Subject: LACK OF HEAT IN PASSENGER COMPARTMENT	Bulletin No: 07-002/02
	Last Issued: 04/22/2002

2001 Millenia models with VINs lower than JM1 TA22** 11 714921, or built before May 9, 2001.

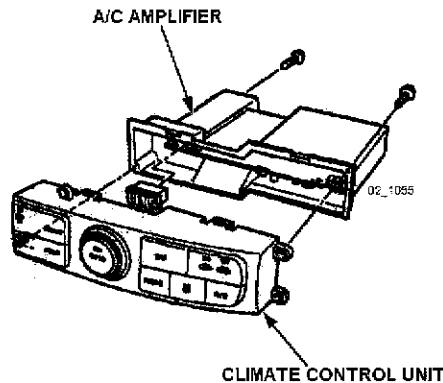
During normal heater usage, the customer may complain of a lack of heat in the passenger compartment. This may occur even if the auto mode temperature control is set high (77 degrees F or higher). The cause may be due to incorrect logic in the A/C amplifier.

To correct this concern, replace the A/C amplifier with a revised part using the following information.

1. Verify customer concern.
2. Follow the Workshop Manual (section 07-40 CLIMATE CONTROL COMPONENT DISASSEMBLY/ASSEMBLY), and replace the A/C Amplifier with a revised part.

Part Number	Description	Qty.	Notes
TC86 61 790C	Auto A/C Amplifier	1	Degrees F
